**VILLAGE OF GERMANTOWN**  
N112 W17001 MEQUON ROAD  
GERMANTOWN, WI 53022

| MEETING:       | <b>PLAN COMMISSION</b>                    |
| DATE AND TIME: | <b>MONDAY, JUNE 12, 2017 6:30 p.m.</b>    |

- IV. **APPROVAL OF MINUTES:** May 22, 2017
- V. **NEW BUSINESS:**
  - A. Stacy Cooke, Agent for Gehl Foods LLC, Property Owner, N116 W15970 Main Street - Rezoning Application (B-3 to M-1) and Certified Survey Map (3-Lot Land Combination).

# CERTIFIED SURVEY MAP NO.

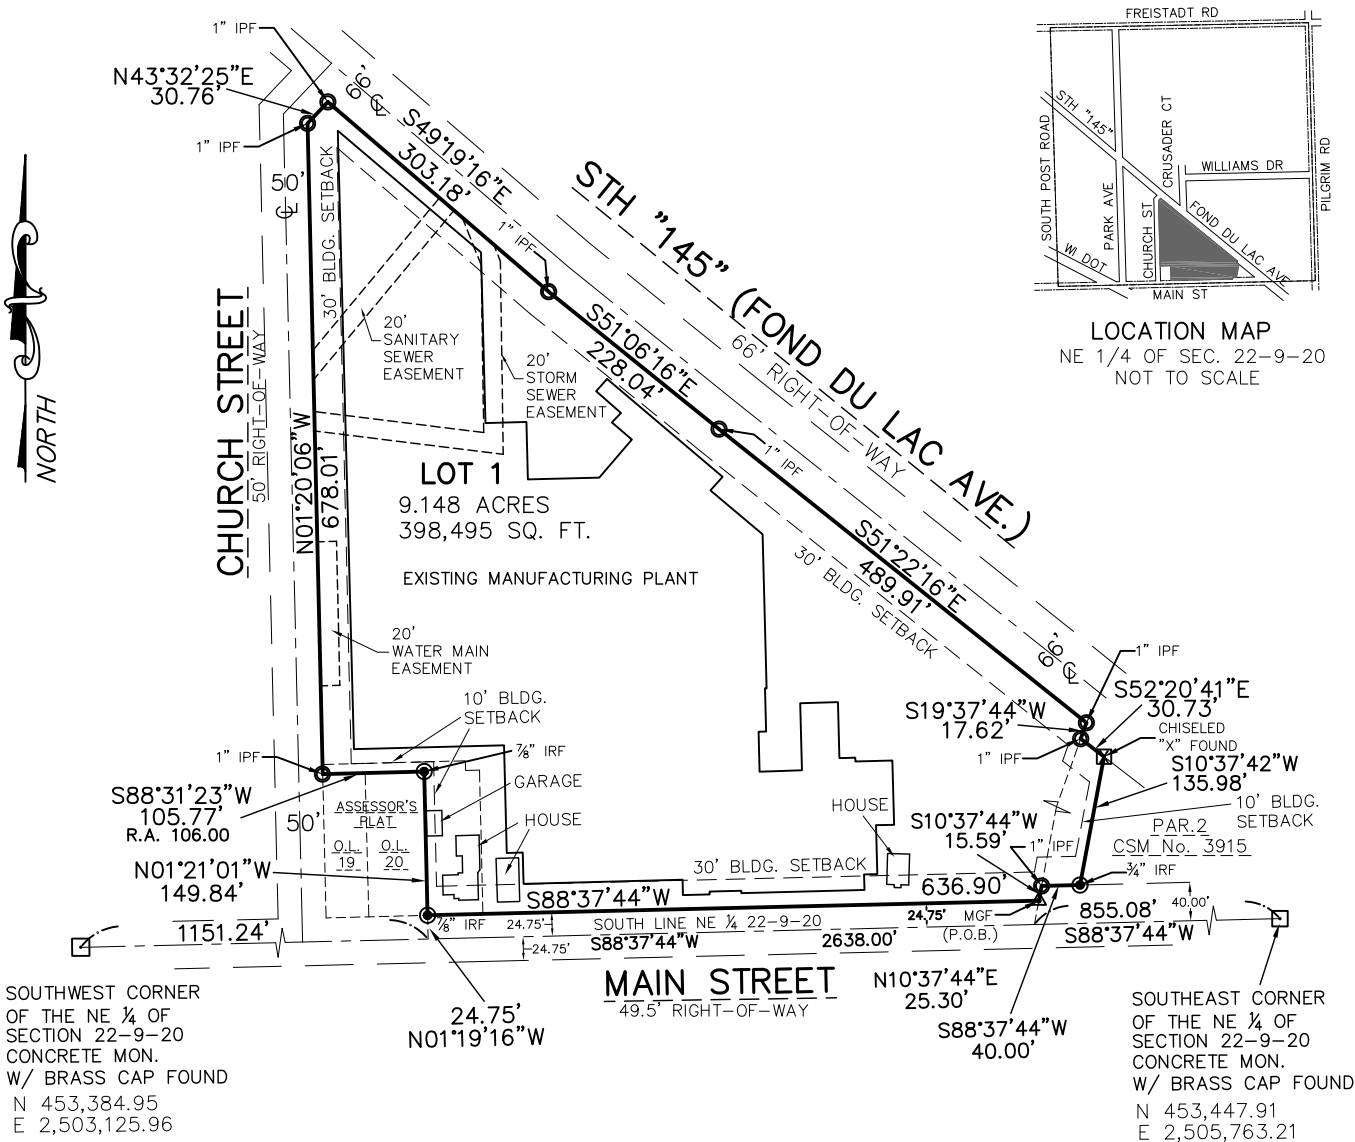
3. Bearing and distance (N10°37'44"E, 25.30') label floating and not tagged to any particular line on Sheet 1. No leader line or line number. It appears to be part of the tie-in dimension from the section corner.

4. Need detail of sanitary, water main and storm easements with bearing and dimensions and ties to the exterior boundary as these easements are not parallel to any exterior lines.

5. Bearing basis is incorrect. The bearing of the south line of the Northeast ¼ of Section 22 is North 88°37'57" East per SEWRPC control summary. All bearings on Sheet 1 and in the legal description in the Surveyor's Certificate need to be adjusted.

6. Need a detail or dimension of the garage to the exterior boundary to see if the garage encroaches into Outlot 20.
7. Need to add a note that existing buildings encroach into existing building setback as defined by Village Zoning Code on May 30, 2017.

1. All technical corrections and issues raised by the Village Surveyor in the May 30, 2017 memo shall be addressed and/or corrected prior to recording the CSM.
2. Site development and building plan approval by the Village Plan Commission is required prior to making any alterations and/or improvements to the two residential lots subject to rezoning and combination and the residential dwellings thereon. Unless superseded by or supplemented with additional and/or different issues and requirements, all site development issues raised by the Village departments summarized in the staff report & recommendation dated June 12, 2017 shall be addressed in the site development and building plan application submitted to the Village.

| REV. BY:                                                                                                                   | DESCRIPTION  | REV. DATE                | REV. # |
|----------------------------------------------------------------------------------------------------------------------------|--------------|--------------------------|--------|
| Sheet:                                                                                                                     | <b>A1.1</b>  |                          |        |

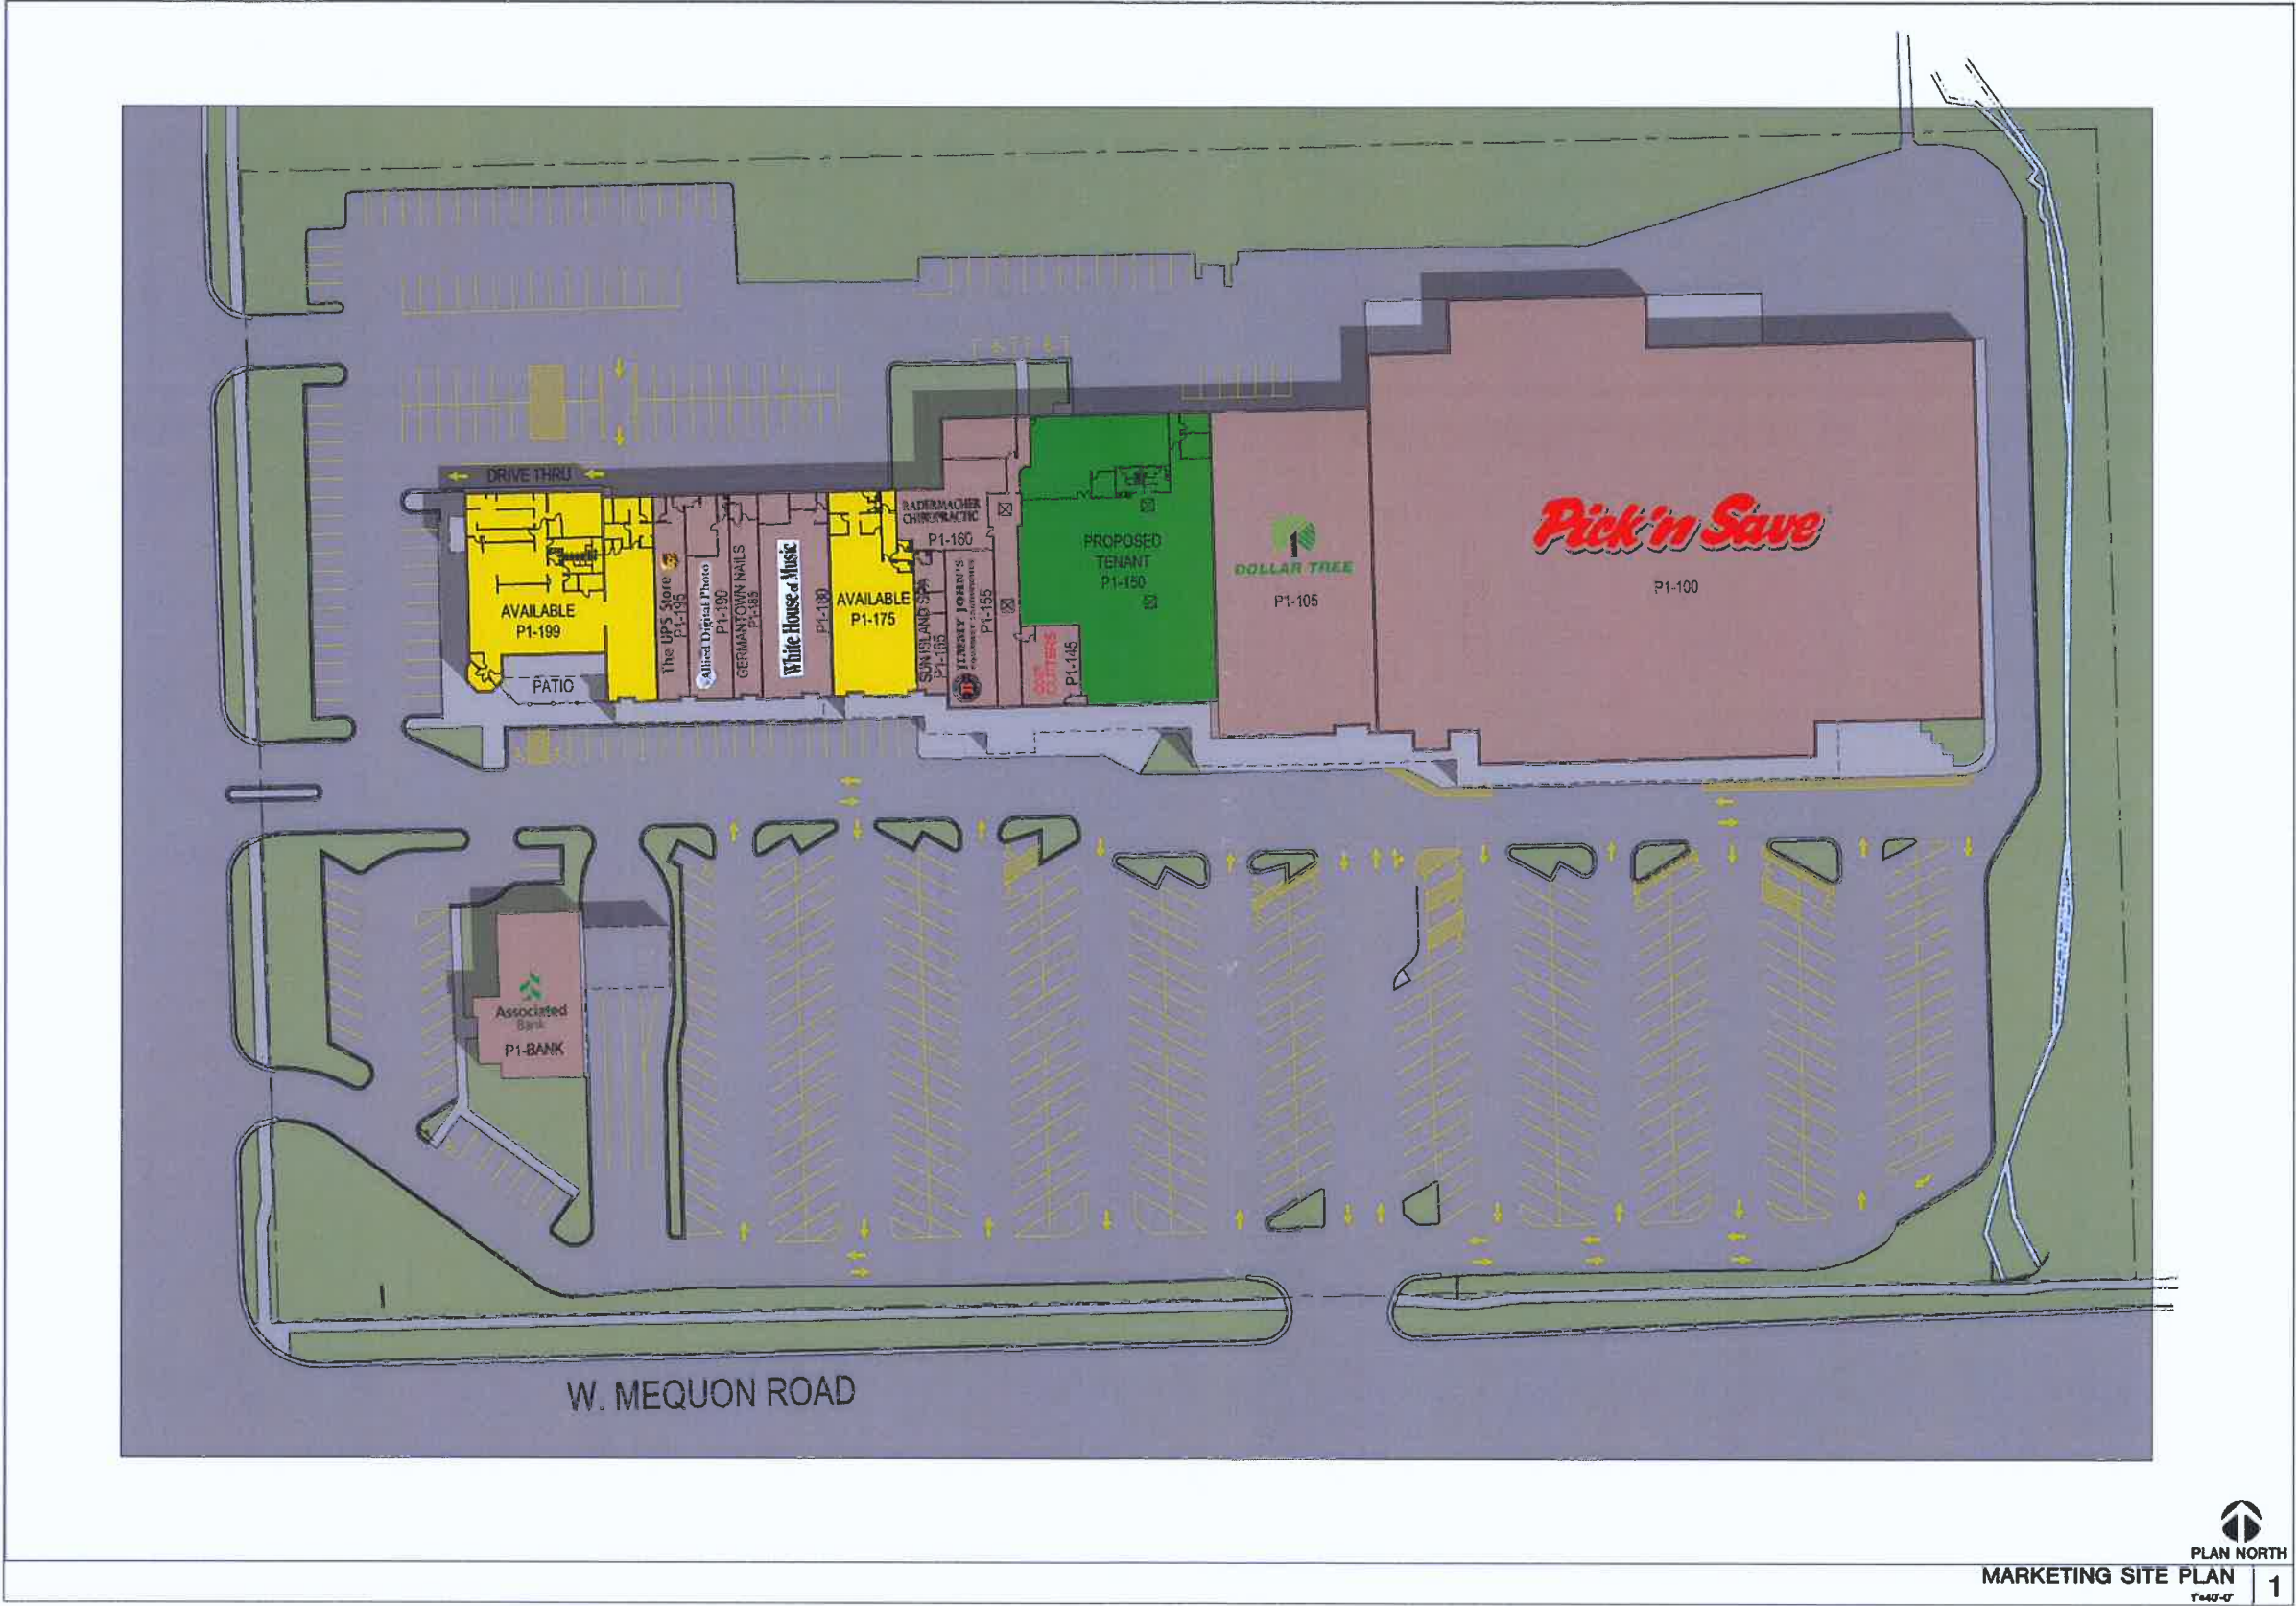
1. The existing fire sprinkler system shall be modified per IBC building codes. Sprinkler heads are not allowed to be turned upright (as shown on sheet A1.1) may not meet required design standards. Building plans should be submitted to the WI DSPS as necessary to ensure building and fire code compliance.
